SUBJECT: Forwards response to Equipment Qualification Branch request for info re seismic qualification of equipment. Justification provided for test response data not completely enveloping required response spectra at lower frequencies.

Subject: Docket Nos. 50-361 and 50-362
San Onofre Nuclear Generating Station
Units 2 and 3

Enclosed are sixty-three (63) copies of responses to Equipment Qualification Branch questions and comments concerning the seismic qualification of equipment, Licensing Open Item No. 6. Enclosure 1 is a list of the responses which are included in Enclosure 2.

RESPONSE TO QUESTIONS RAISED BY NRC AS SORT GENERAL CONCERNS FOR SAN ONOFRE
UNITS 2 & 3

FIGURE I

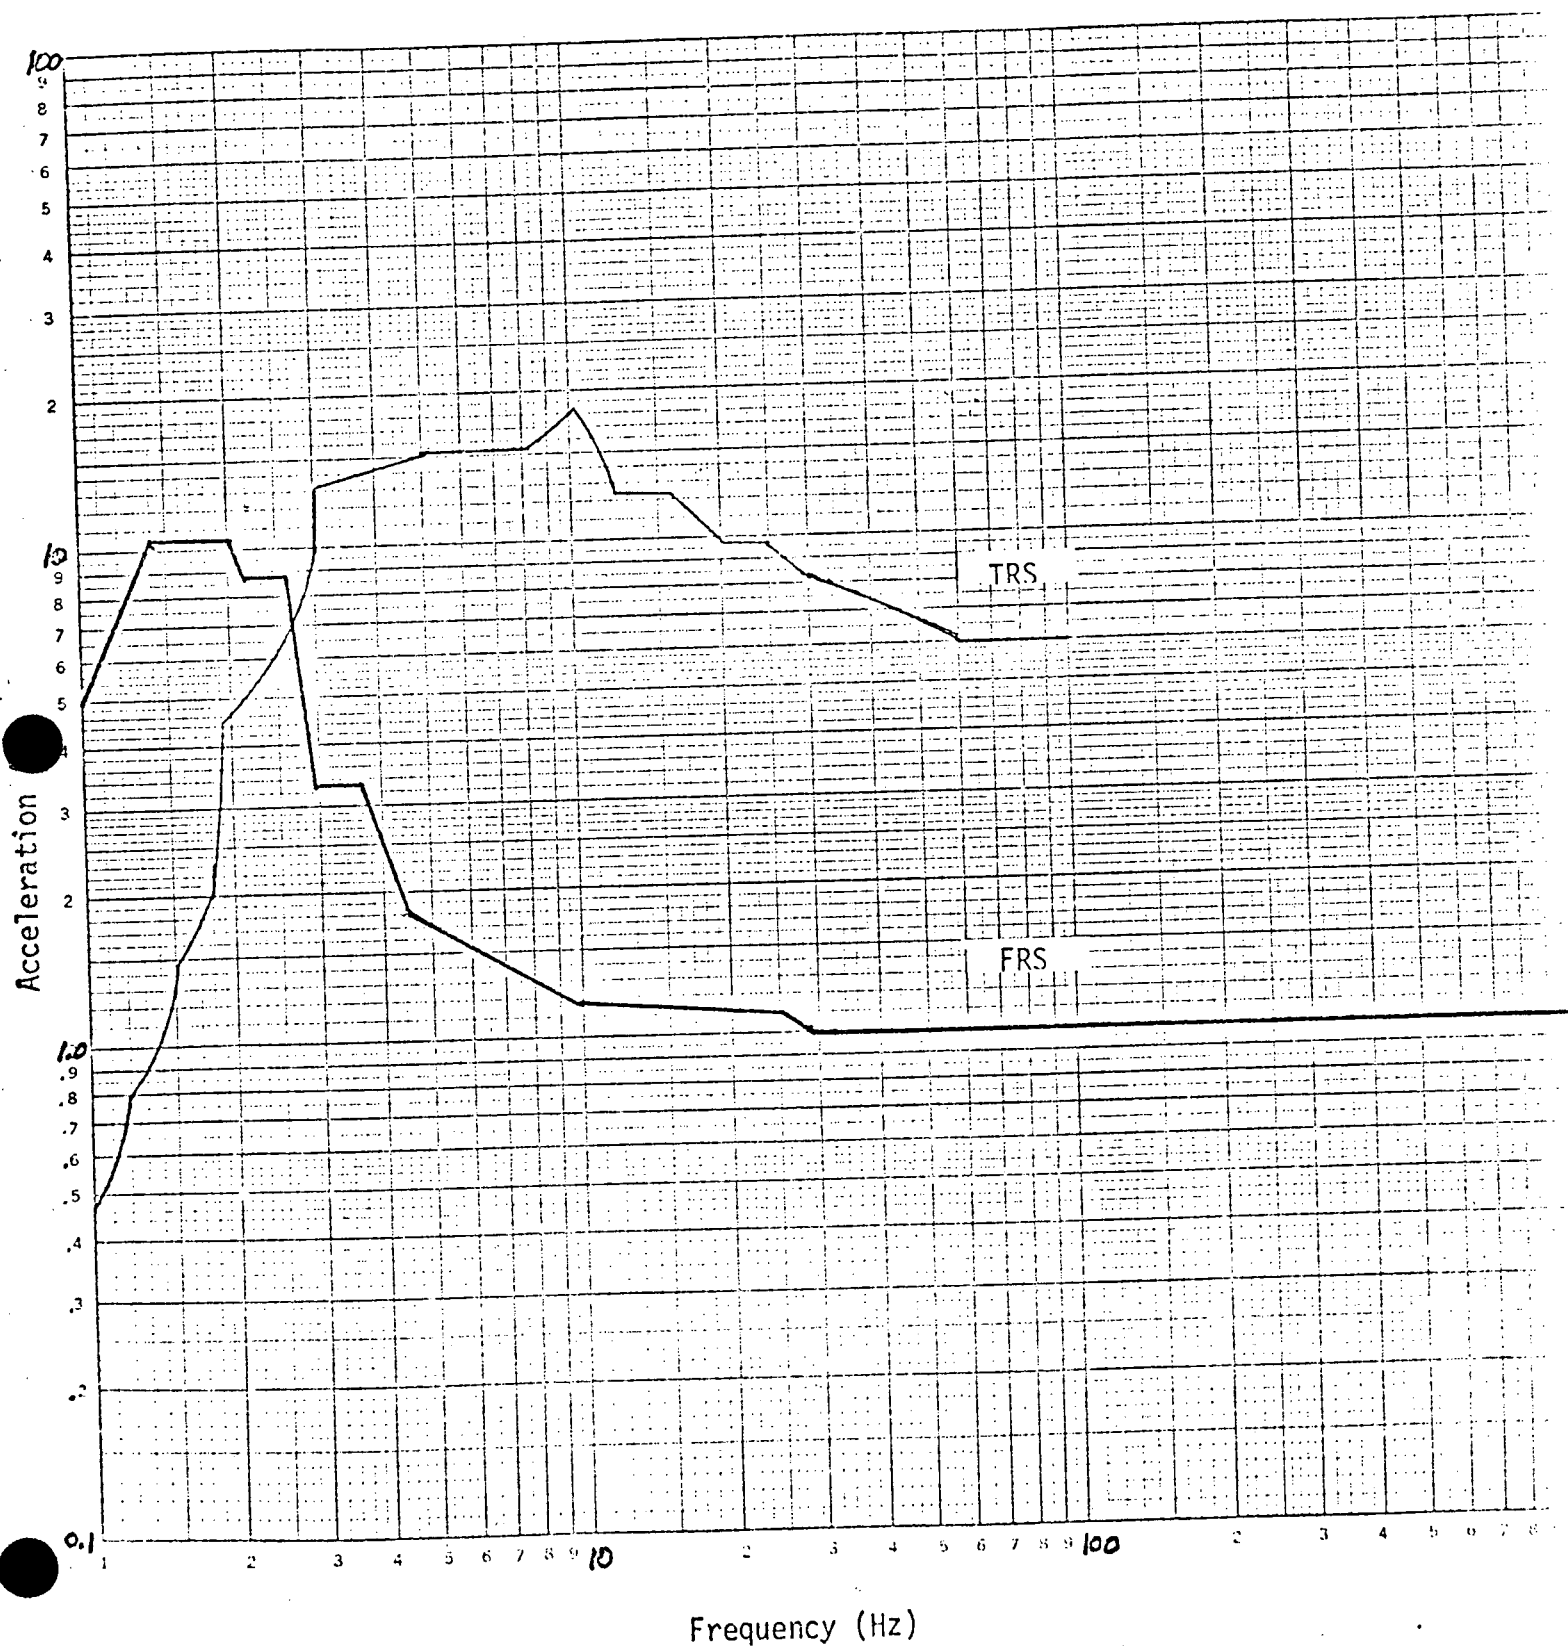
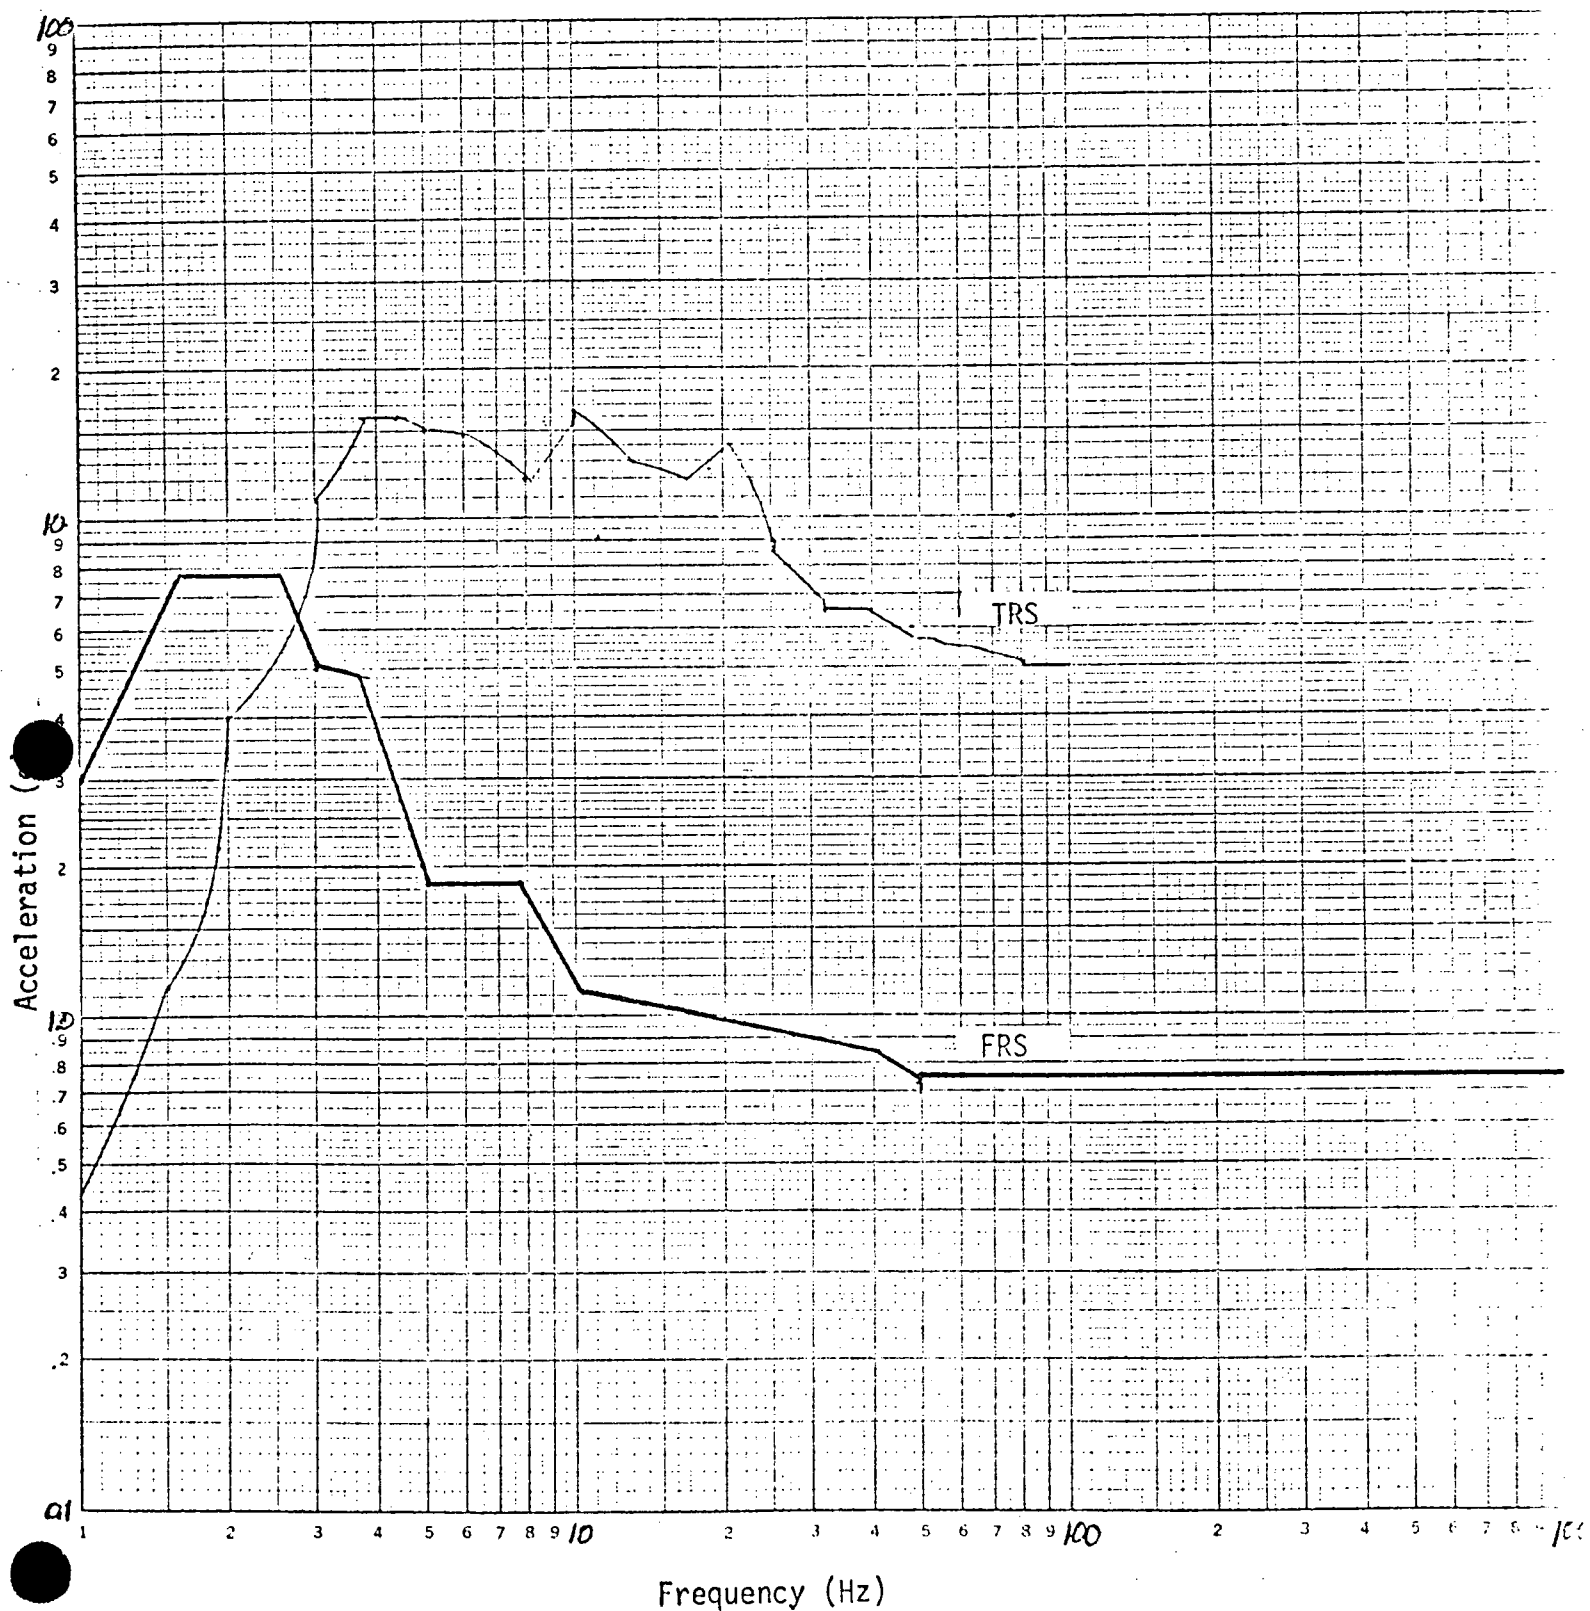
d. Question:

1. Figures I and II indicate that sufficient margin is present to account for any small amount of amplification which might occur in the cabinet due to the light coupling involved.
2. The rigidity of circuit board mounting is considered sufficient to eliminate any concerns relative to the enveloping of the RRS.

FIGURE III

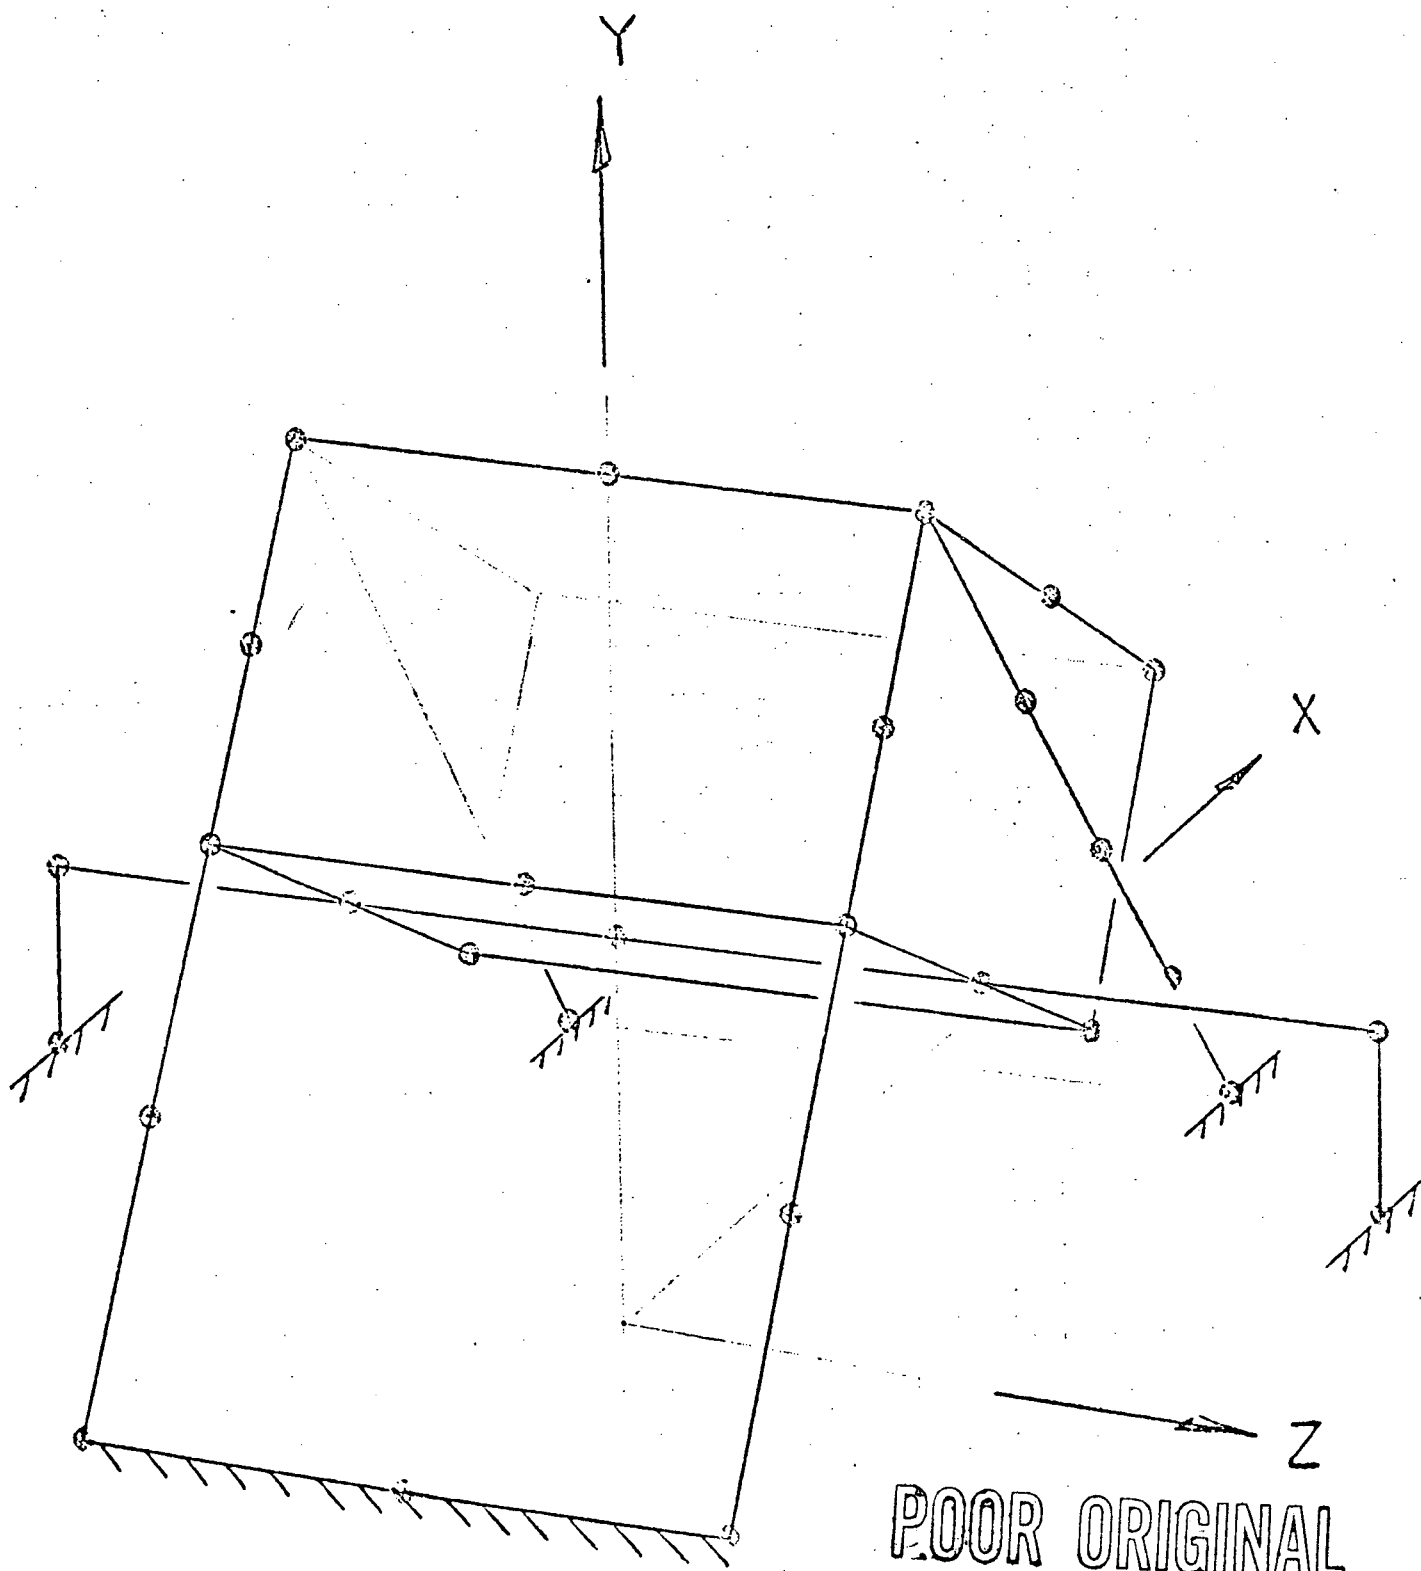
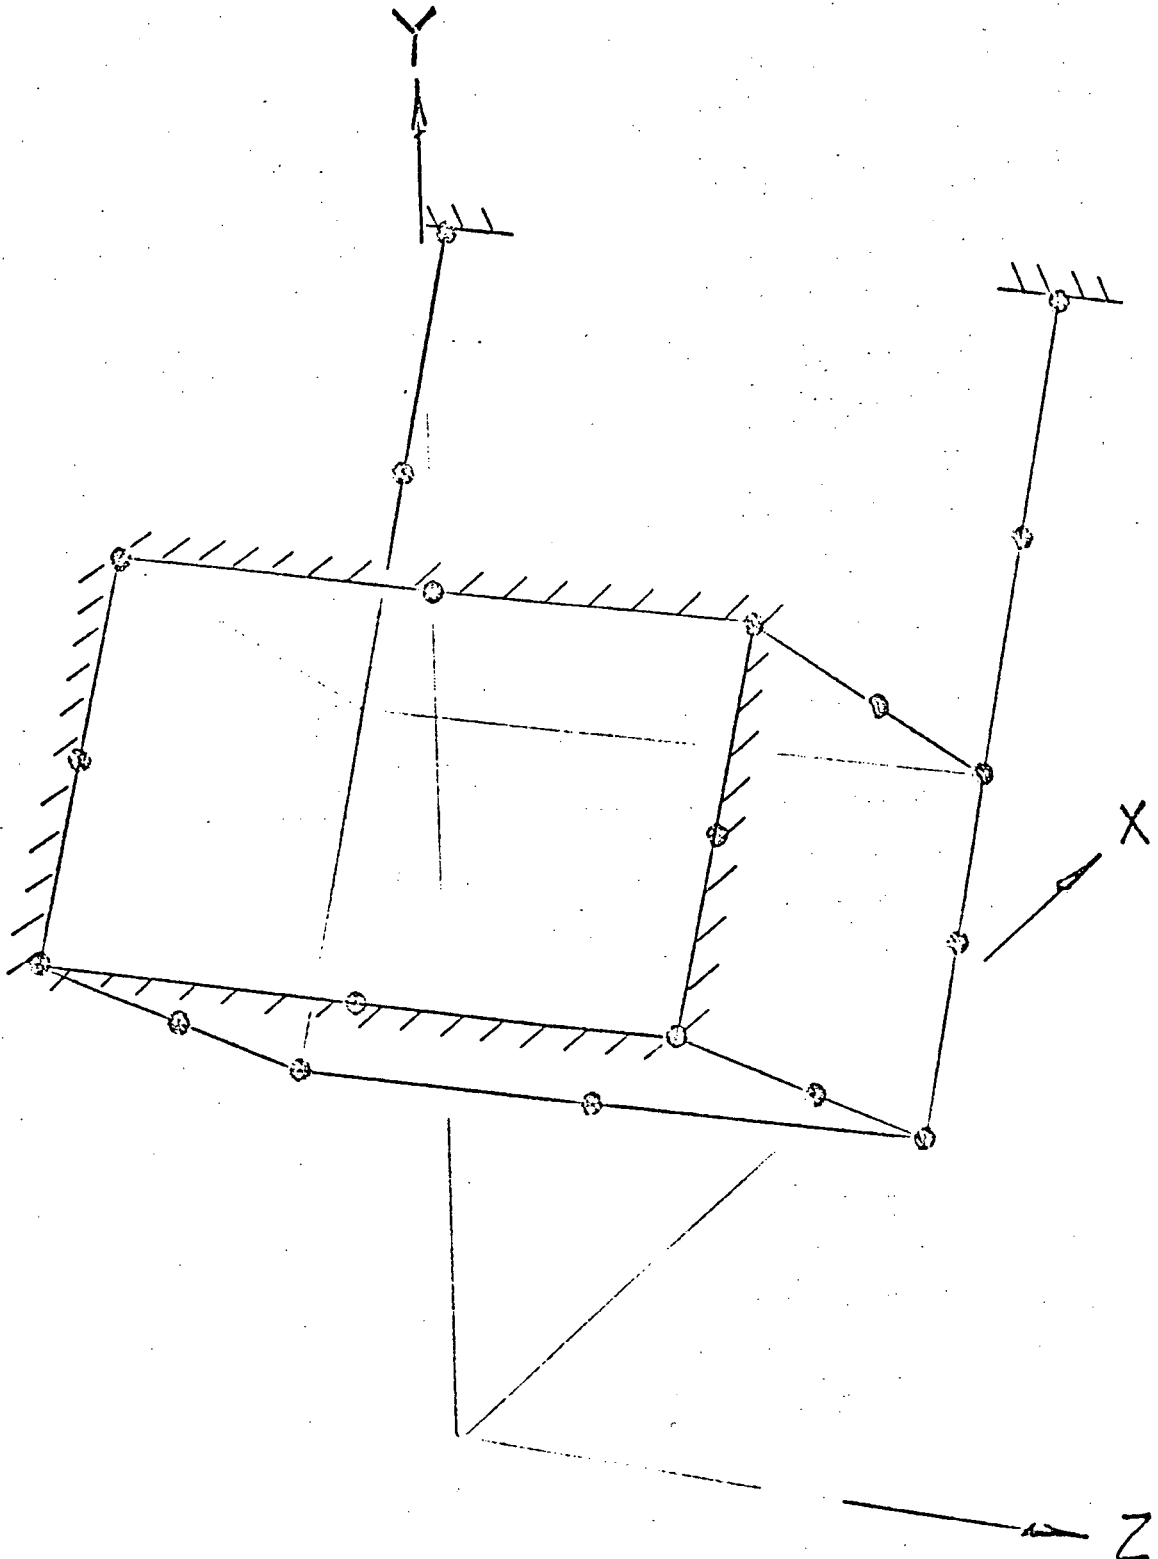
Provide justification for equivalence between the test configuration and the actual installed configuration for CPC Operators Module (NSSS 7).

The supporting structure used to excite the CPC Operator's Module is shown in the Wyle Report No. 43130-1. The actual field installation mounting structure is somewhat different from that used during the Seismic Test Program. Modal Analysis of the two structures is used to compare the mountings and assess the dynamic response that is experienced by the module in each configuration.

Comparison of the modeshapes and frequencies shows the first mode in each case to represent the mounting structures while the others indicate local responses of the sides, top and bottom of the CPC module. The test structure has a frequency slightly higher than that of the field installation (109.5 Hz and 100 Hz, respectively). The field installation response is primarily motion of the rear struts while the test structure modeshape includes significant motion of the module as well.

1. Based upon the assumption of a single degree-of-freedom system, the ratio of forcing frequency to response frequency indicates the magnification factor of both structural mountings to be virtually the same.
2. Motion of the module is not significant in the first mode of the field installation but is significant in the test configuration. We may therefore say that the module was more severely excited during the test than it would be during field installation under the same dynamic conditions.
